Paducah Gaseous Diffusion Plant (PGDP)

Review Report: Building C-400 Thermal Treatment 90% Remedial Design Report and Site Investigation, PGDP, Paducah Kentucky

15 August 2007

Figure A3 – MIP Boreholes and ECD response overlaying interpolation of PID responses in the Southeast Source Zone area (looking North).

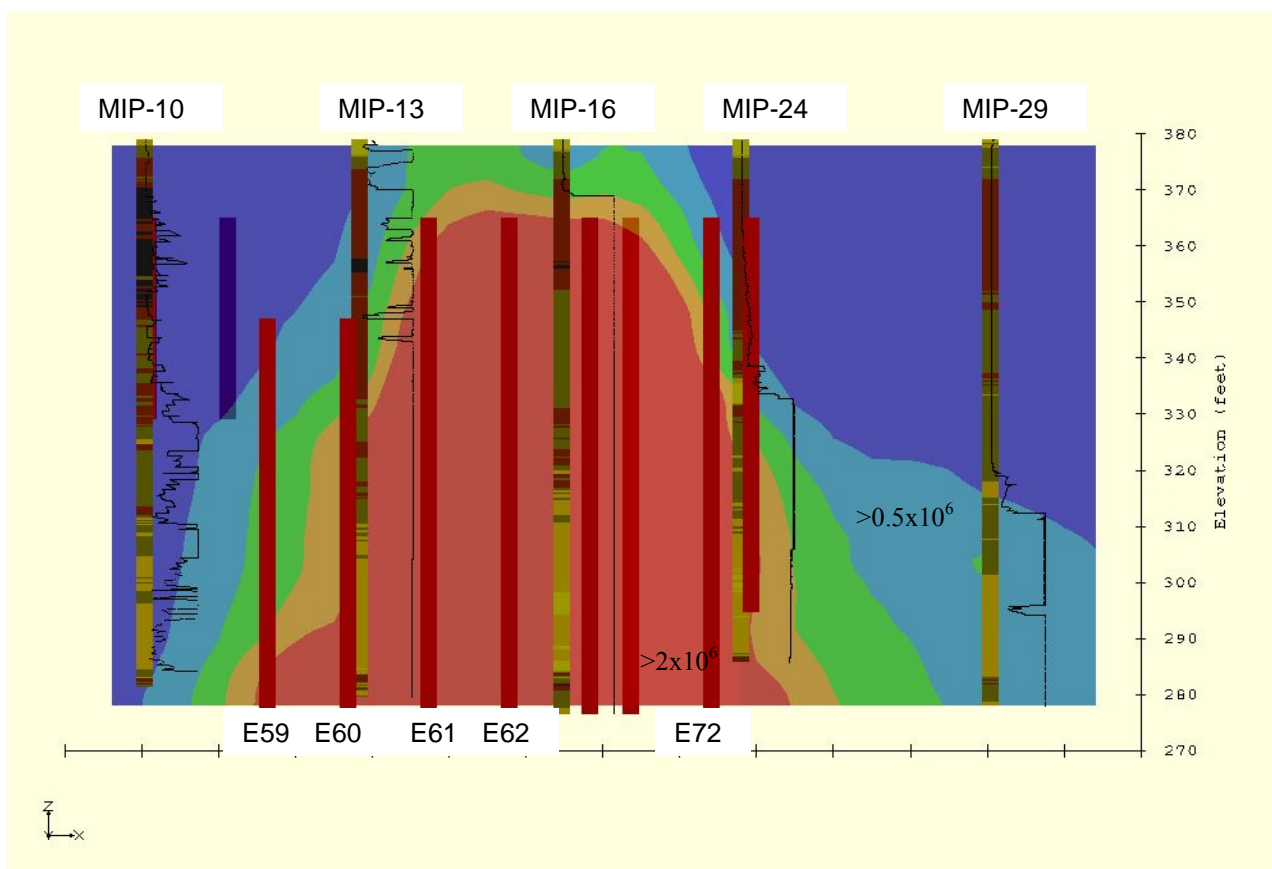
Figure A3 is a cross-section from the C-400 southeast source zone region where the color filled contours represent an interpolation of the MIP PID data. The red color represents responses greater than 2×10^6 uV and the light blue are responses between 1 and 0.5×10^6 uV. Overlaying the contours are MIP borehole logs where the black line associated with each MIP borehole is the discrete depth ECD responses in uV. Also shown are the proposed locations of ERH electrodes indicated as red columns.

Since no confirmation soil or groundwater samples were collected from the MIP boreholes, the PID responses associated with neat TCE (i.e., TCE NAPL) are unknown. However, there were two other detectors used to analyze the gas stream collected by the MIP including the FID and ECD. While the FID responses were similar to that of the PID (not shown), there appears to be a relationship between the interpolated PID values to the ECD responses as shown in Figure A3. For example, the PID response from MIP29 between 68 and 76.6 feet bgs (311 and 302 feet elevation) was greater than 2×10^6 uV and the ECD detector was at the maximum response of 1.3×10^7 uV in this region as well. The similarity between the maximum ECD and PID responses that suggested the presence of neat TCE are also evident in the MIP13, MIP16, and MIP24 results. Why the thermal treatment volume was not extended 80 feet to the east to encompass the MIP29 location, where there were a few PID responses greater than 9×10^6 uV PRS DNAPL value near 75.7 feet bgs, is unclear.

Figure A4 – MIP Boreholes and ECD response overlaying interpolation of PID responses in the Southeast Source Zone area (looking West).

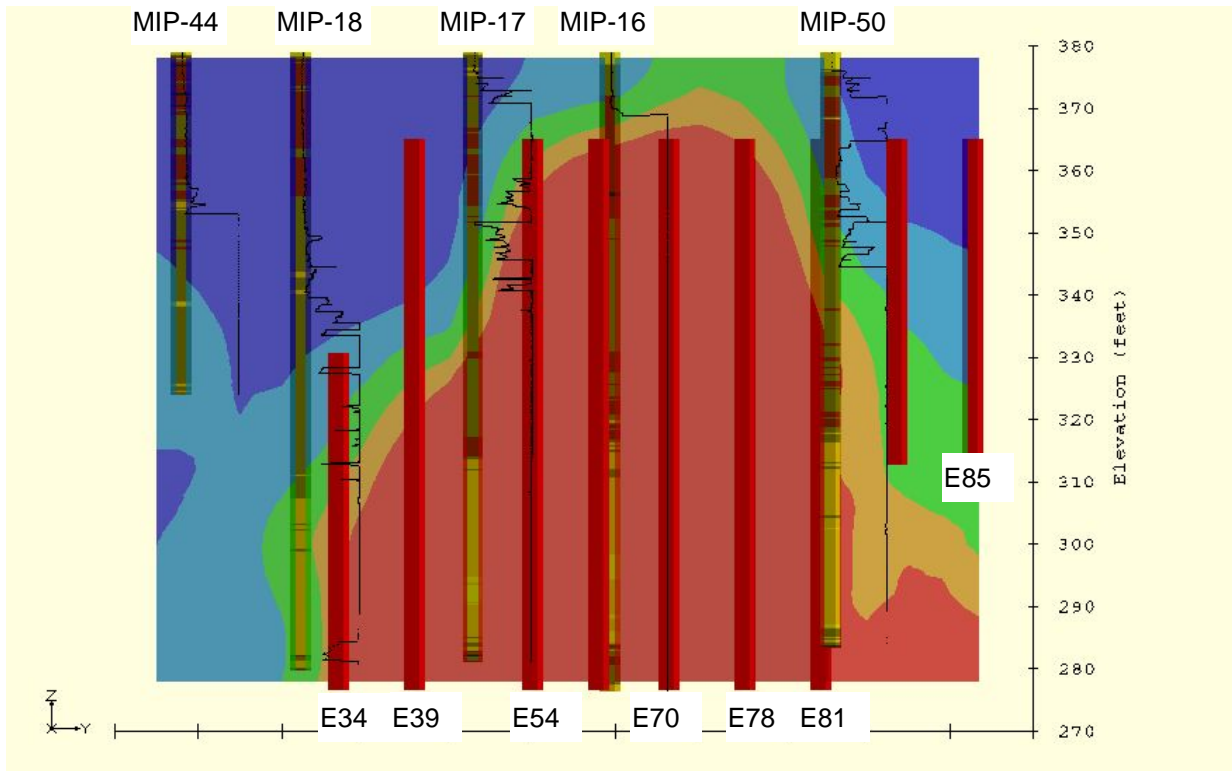
Figure A4 shows that the ECD response and PID interpolations suggest contaminant levels that may indicate the presence of neat TCE to the south of MIP18. However, since MIP44 only extended to 55 feet bgs, there is insufficient data to support the assumption that MIP18 defined the southern most limit of neat TCE. North of MIP50, the treatment volume extends to 66.3 feet bgs while there is the potential for neat TCE to be present at depths of up to 104 feet bgs based on the PID interpolations and the ECD response from MIP50.

Figure D1. Estimated Electrode Radius of Influence in the Saturated Zone

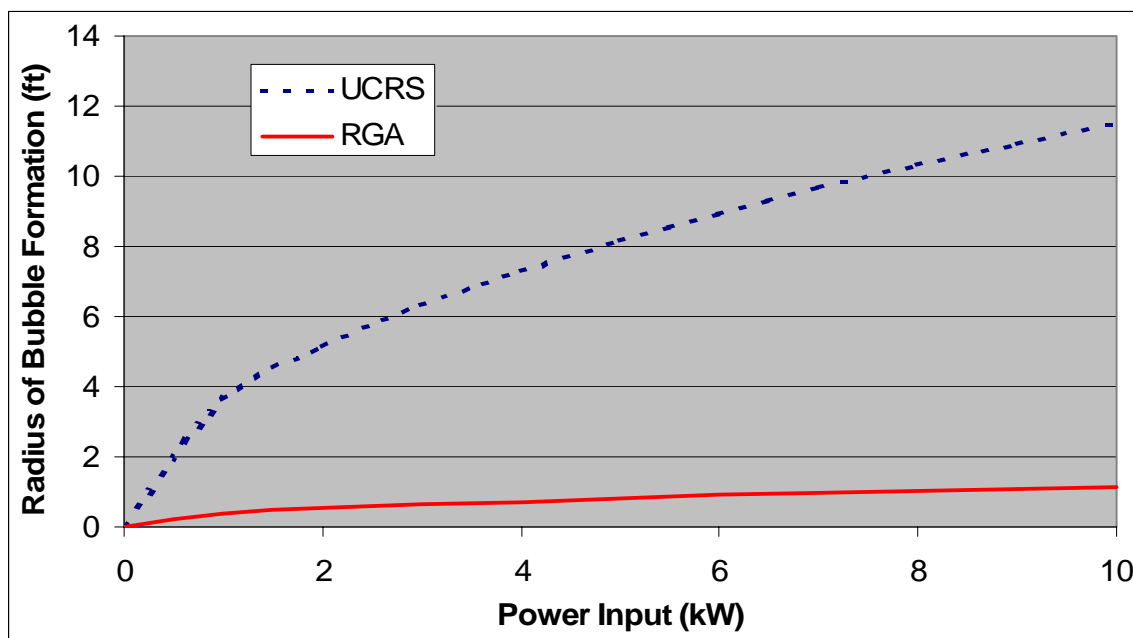
Values to estimate the radius of the zone of bubble formation around the electrodes in the saturated portions of the UCRS and the RGA utilizing equation (5) are provided in Table 1. The radii are plotted in Figure 1 as functions of the input power to the electrode. The electrode power is approximately 6,800 kW and, as indicated, the UCRS is expected to have a bubbling radius close to 10 feet. However, the high permeability of the RGA yields a radius less than 2 feet. These calculations are conservative because the model does not account for the somewhat uniform heating of the electrical power and lateral heat conduction. This simplistic model is most applicable at the bottom of the RGA since the top of the RGA is bounded by the lesser permeability of the UCRS. Hence, the results are cause for concern that heating the bottom of the RGA to steam temperatures may not be feasible. The influx of cool water replacing volatilized water will be very rapid and the energy requirements for heating very large. Extending electrodes into the top of the McNairy formation provides a good opportunity to extend the zone of bubble formation but replenishing the water in the McNairy pore space to prevent drying out may limit this effect.

Figure D2. Estimated Shape of the Steam Injection Front in the RGA

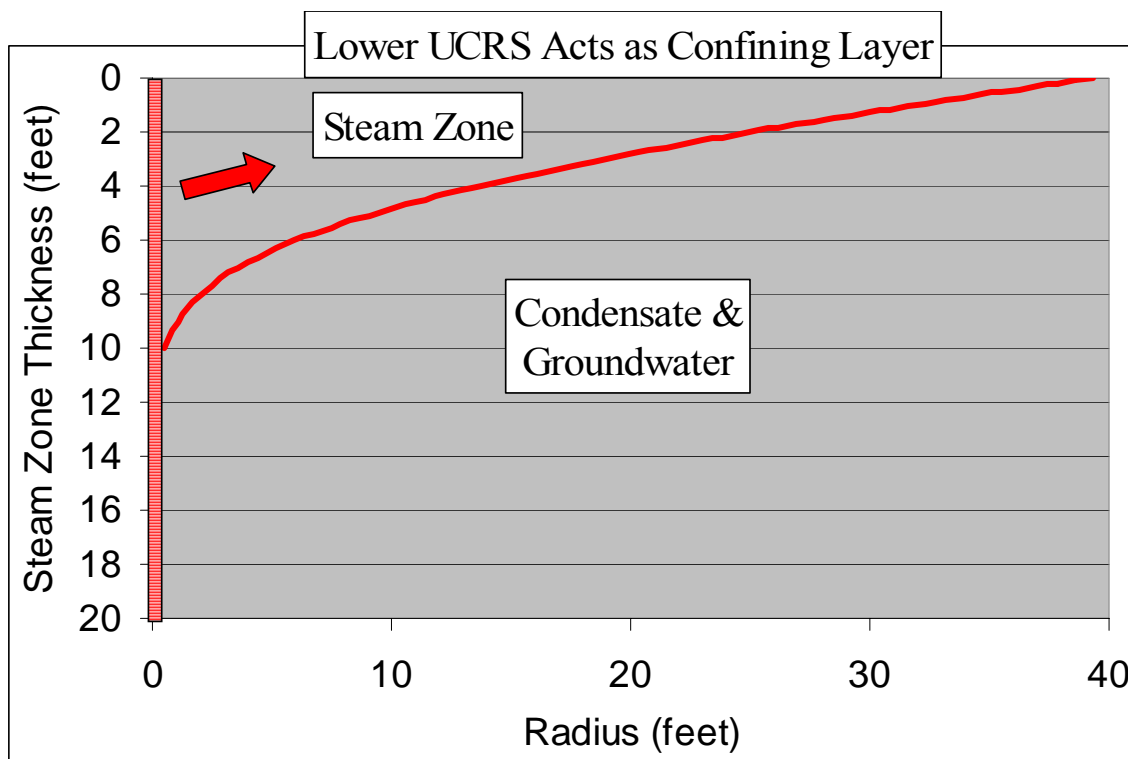
The shape of the steam front resulting from injection of steam into the RGA at the design rate of about 2,000 pounds per hour was estimated utilizing the model of van Lookeren (1983). The result of the calculation is illustrated in Figure 2. The steam zone exists around the injection well only above the red line and liquids exist below. This plot suggests that the bottom of the RGA will not be significantly heated by steam injection. Any DNAPL in this region will not be displaced and recovered. Further, attempts to mitigate this effect by screening deep in the RGA would not be successful as buoyancy and the path of least resistance would bring the steam zone to the top of the RGA before

lateral growth could be achieved deep in the RGA. The recommendation is to eliminate the steam injection activity and verify the area requires treatment before proceeding with any remedial action in this previously treated volume.
